# Access Compliance Report

## Public Rights-of-Way

### (Curb Ramps)

Intersection ID: 48134	Main Street: SQUIRREL_TRAIL_LN	Cross Street: ACORN_CREEK_LN	Location: SW
ADA ID: E3CE5AFC96EE	Ramp Type: PerpDiag	Initial Pass/Fail: Fail	Overall Compliance: No
Severity Score: 8.75			
Codes/Mitigation Info/Possible Solution		Field Measurements/Component Compliance

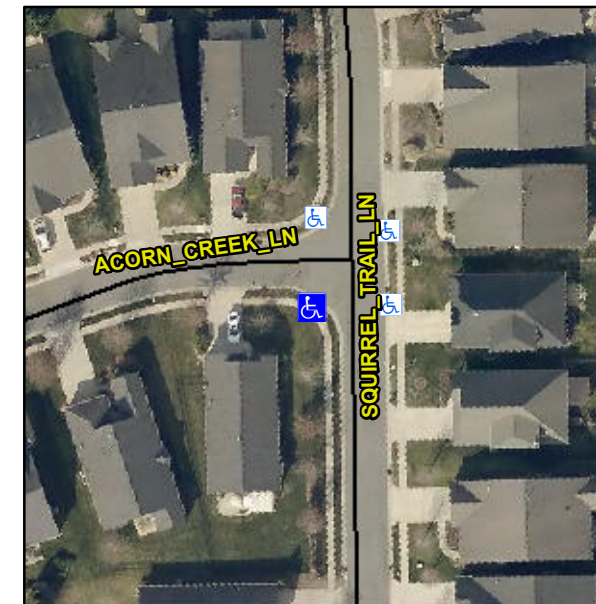
**Not Found, R304.5.1**

Compliance	Description	Data	Compliance	Description	Data
N/A	Ramp Length (in)	46.0	Yes	Ramp Slope (%)	6.2
No	Ramp Width (in)	38.0	Yes	Ramp XSlope (%)	1.7
N/A	Flare Type LT	N/A	N/A	Flare Type RT	N/A
N/A	Flare Slope LT (%)	N/A	N/A	Flare Slope RT (%)	N/A
N/A	Flare Traversable LT?	N/A	N/A	Flare Traversable RT?	N/A
N/A	Landing Length (in)	N/A	N/A	DWS Provided?	N/A
N/A	Landing Width (in)	N/A	N/A	DWS Contrast?	N/A
N/A	Landing Slope (%)	N/A	N/A	DWS Length (in)	N/A
N/A	Landing X Slope (%)	N/A	N/A	DWS Full Width?	N/A
N/A	Landing Curb? (Y/N)	N/A	N/A	DWS Offset (in)	N/A
N/A	Shared Landing?	N/A			
N/A	Gutter Ponding?	N/A	N/A	Gutter Slope (%)	N/A
N/A	Gutter Lip Ht (in)	N/A	N/A	Gutter X Slope (%)	N/A
N/A	Painted X Walk1?	No	N/A	Painted X Walk2?	No
	X Walk 1 Direction	To E		X Walk 2 Direction	To N
N/A	X Walk 1 Width (in)	N/A	N/A	X Walk 2 Width (in)	N/A
	X Walk 1 Slope (%)	0.2		X Walk 2 Slope (%)	2.5
	X Walk 1 X Slope (%)	1.1		X Walk 2 X Slope (%)	0.1

**Remove & Replace Curb Ramp With Two New Directional Ramps or Equivalent.**
